STAFF REPORT

ITEM: Wyndham Village Preliminary Plat and Zoning Map Amendment

Re: Wyndham Village Preliminary Plan Review

PRELIMINARY PLAT WYNDHAM VILLAGE

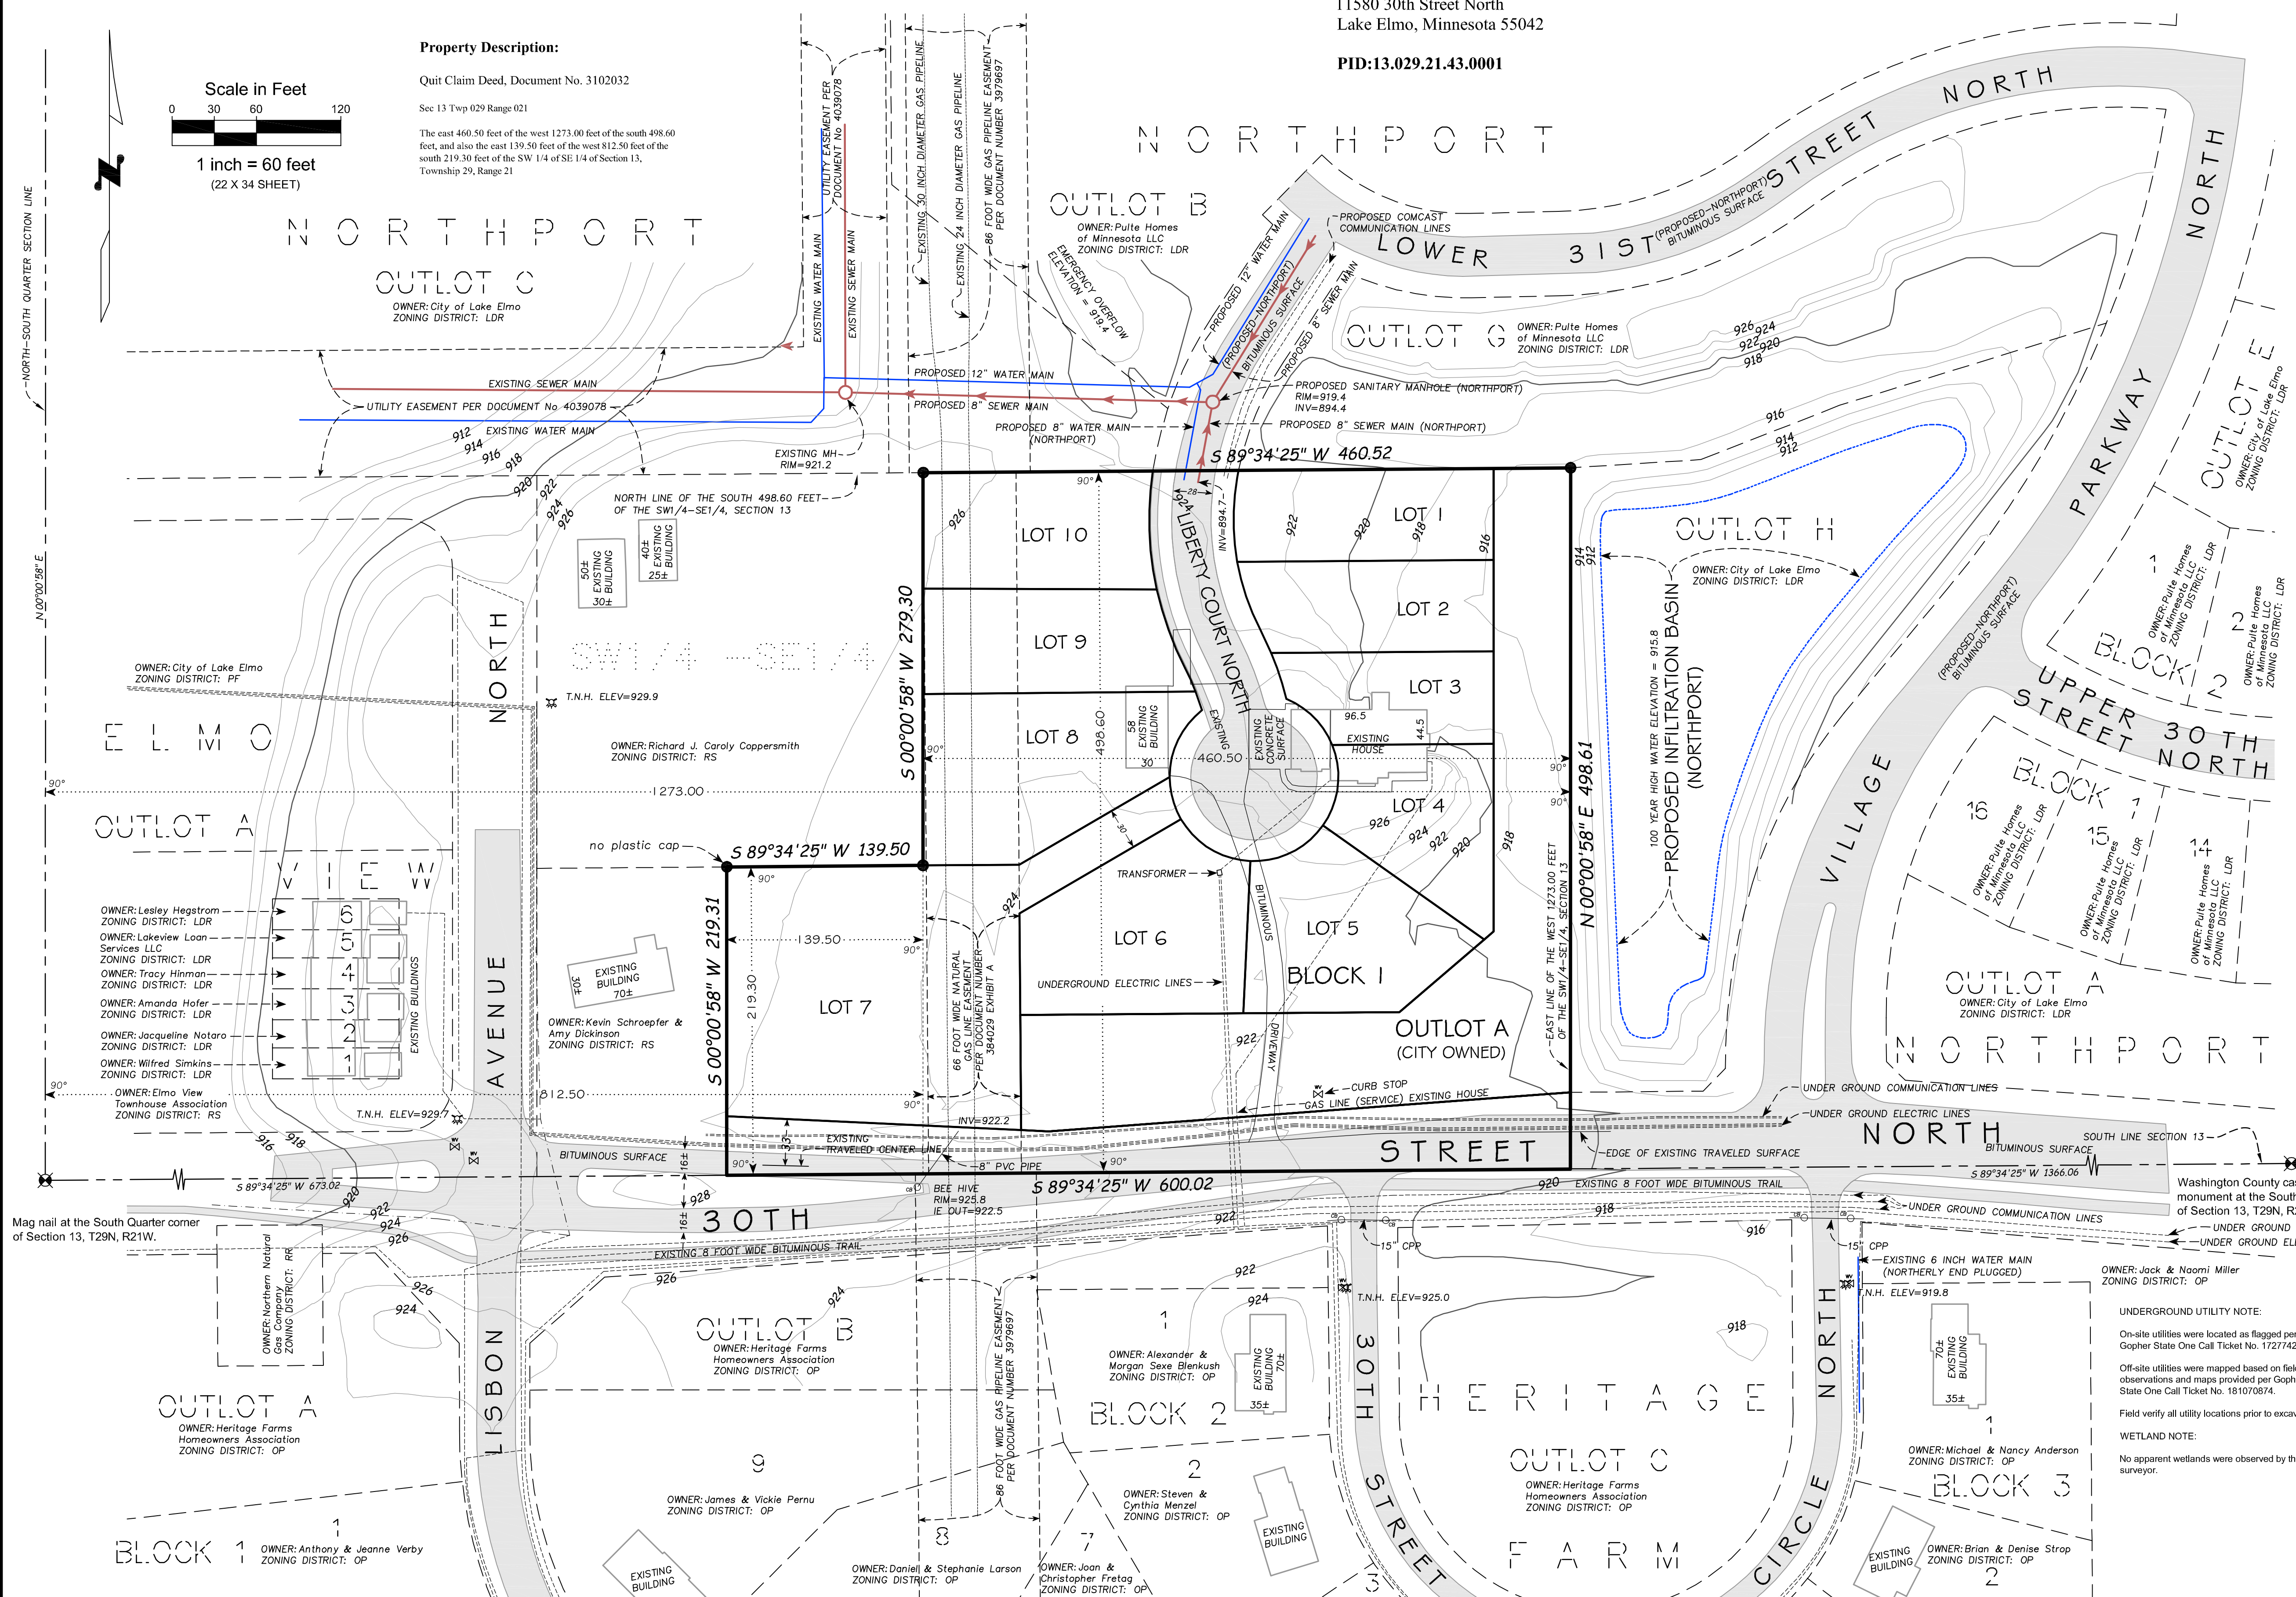
Lot Dimensions and Bulk Requirements. The proposed sketch plan appears to meet the lot dimensions and bulk requirements for the Village Urban Low Density Residential zoning district, except for Lot 1. This is the only lot that does not meet the required lot width at the setback line. It is a recommended condition of approval that this lot width be increased to 70 feet.

4. Preliminary plat and plans should be revised to dedicate additional right-of-way along 30th Street and/or to expand the storm water to the 100-year High Water Level (HWL) flood area.

- Right-of-way/Easement Dedication. The Preliminary Plat and all preliminary plan sheets must be revised to dedicate additional right-of-way along 30th Street North to ensure a minimum 30th Street boulevard of 16 ft. along the entire length of the plat. The current plans show a varied boulevard width from 11-25 feet. In addition, a 10 ft. utility corridor must be reserved (at boulevard grades) for small utilities. The proposed storm water facilities (including the 100-year HWL) must be revised further north to prevent encroachment onto the 10 ft. utility corridor.

- Outlot A must be dedicated to the City for storm water maintenance. Outlot A has been shown as City-owned on the preliminary plat and plans as required. Outlot A may need to be revised to accommodate additional right-of-way along 30th Street and/or to expand the storm water 100-year HWL flood area.

- Drainage and utility easements are required over all storm sewer, sanitary sewer and watermain not located on City Outlots and right-of-way, minimum 30-feet in width centered on the pipe/structure. Easements must be shown on the Preliminary Plat, Utility Plans and Grading Plans.

9. The preliminary landscape plan shall be approved by the City prior to recording of the final plat.
10. The lot width of Lot 1 shall be increased to 70 feet, and all other lot dimension and bulk requirements of the Village Urban Low Density zoning district must be met.
